## Power Equipment

Code: CC-304

SUBJECT: POWER TAKE OFF (PTO) CLUTCH SPACER ON 2130, 2135, 2160, 2165, 2185, 1440, 1641 MODEL TRACTORS. (1995 PRODUCTION)

Figure 1

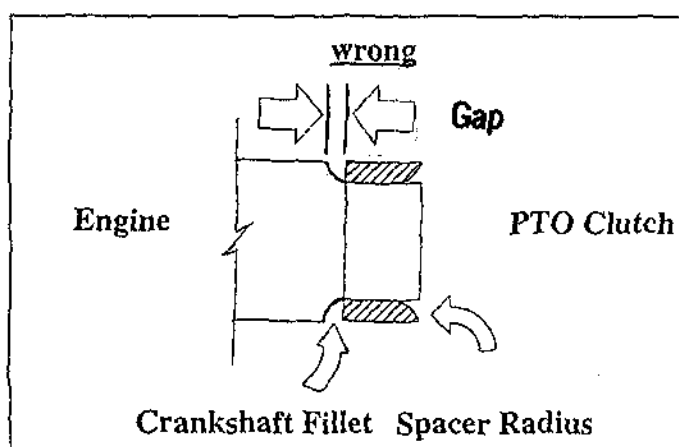
The following instructions are a visual way the service technician can quickly determine if the spacer has been installed properly. First the service technician must remove both side panels from the tractor in an area with plenty of light. Next look behind the PTO clutch, examine the area where the spacer comes in contact with the fillet of the crankshaft as shown in the illustrations below. If improperly installed, a gap will be apparent between the fillet of the crankshaft and the spacer as shown in figure one. If properly installed, the radius of the spacer will be in contact with the fillet of the crankshaft as shown in figure two.
